ATLANTIC COAST PIPELINE, LLC
ATLANTIC COAST PIPELINE
Docket No. **CP15-554-000 &**
CP15-554-001

DOMINION TRANSMISSION, INC.
SUPPLY HEADER PROJECT
Docket No. **CP15-555-000**

Response to Data Request
Dated April 11, 2017

<ul style="list-style-type: none"> Proposed Route Corresponding Segment of Proposed Route Valley Center Route Variation 	<p>Atlantic Coast Pipeline Figure 11-1 Valley Center Route Variation</p>
--	---	---

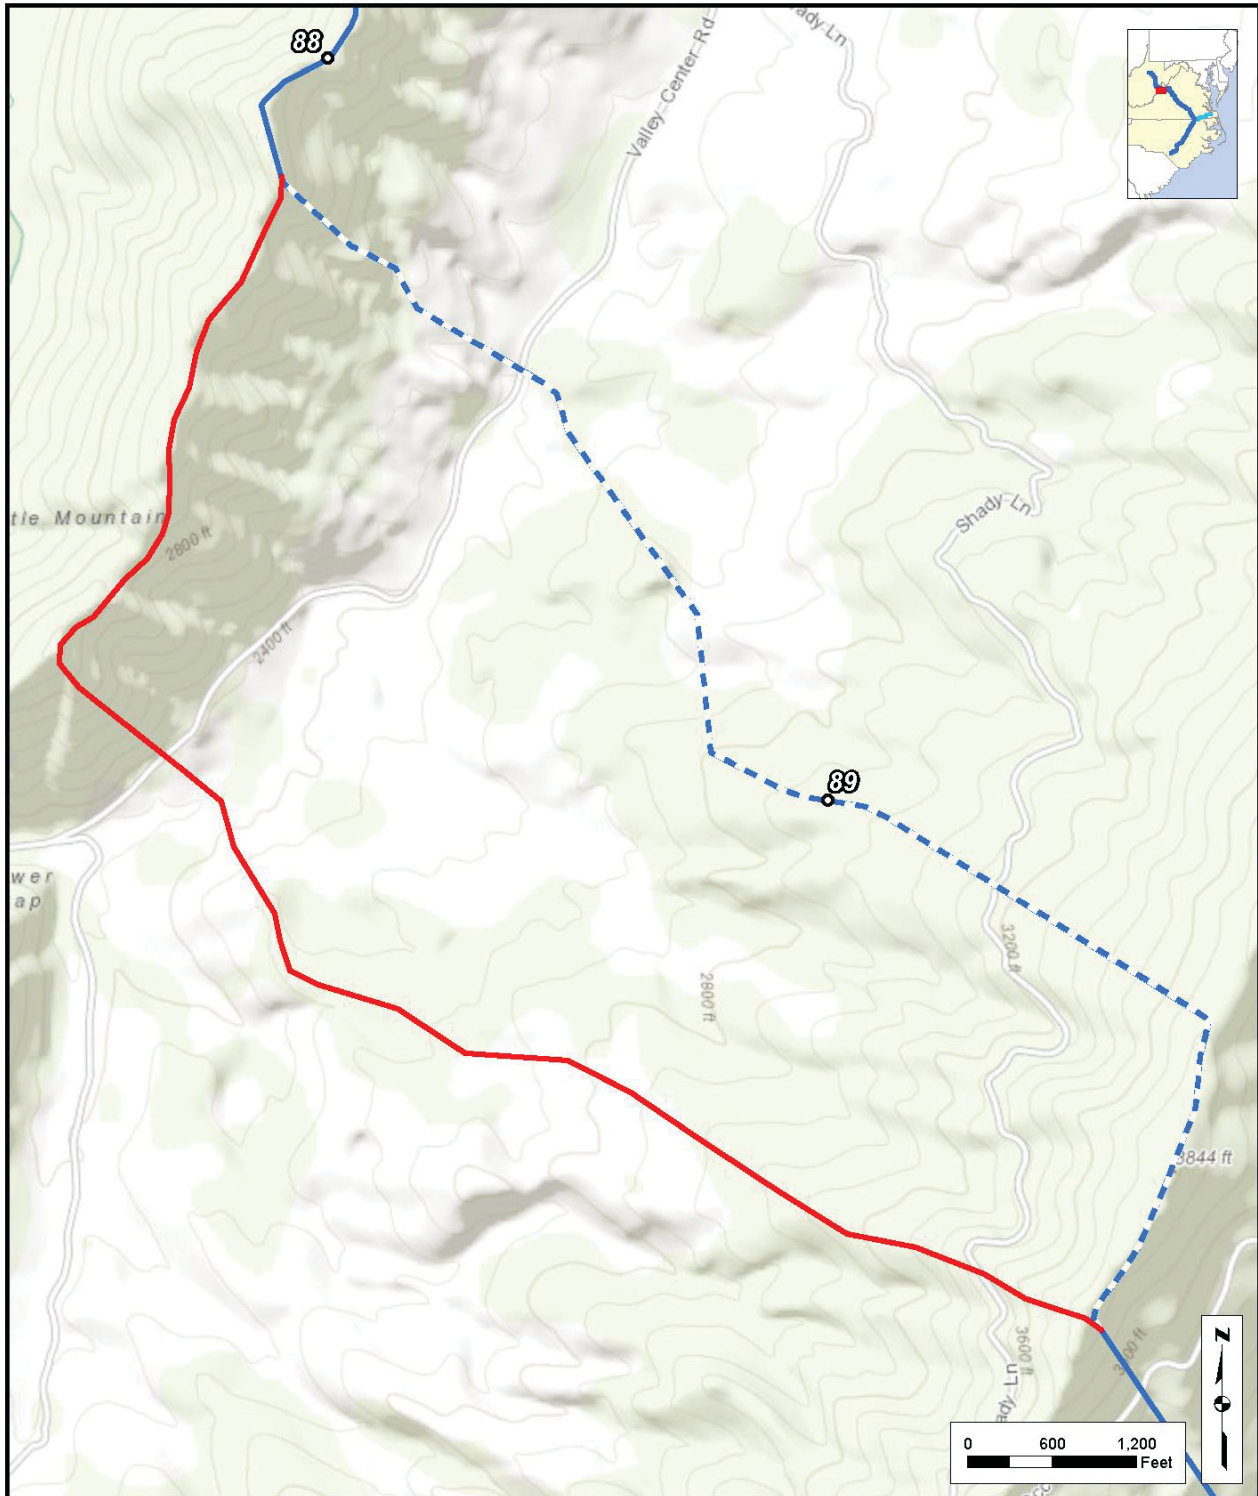
Atlantic has identified a possible alternate route variation between MPs 88.2 and 89.7 to avoid the Valley Center Road karst features (see Figure 11-1). The Valley Center Route Variation leaves the baseline route at MP 88.2 and travels southwest about 0.8 mile along the ridgeline of Middle Mountain. It then turns southeast and parallels the proposed route for about 1.7 miles, before rejoining the proposed route at MP 89.7. A comparison of the proposed route and the possible route variation is provided in Table 11-1.

The Valley Center Route Variation is 0.3 mile longer than the baseline. It crosses one perennial waterbody, whereas the baseline route crosses no perennial waterbodies. The route variation crosses more areas of steep slope, side slope, and moderate to high landslide incidence areas than the proposed route. As shown in Table 11-1, crossings of other resources along the two routes are similar, including one road crossing and one highway crossing.

Field surveys along the proposed route did not identify any federally listed species. Access has not been obtained for surveying the possible route variation; however, similar species surveys would need to be repeated on the route variation if it is adopted. If federally listed species are found, Atlantic would need to coordinate with the FWS to determine appropriate conservation measures for these species.
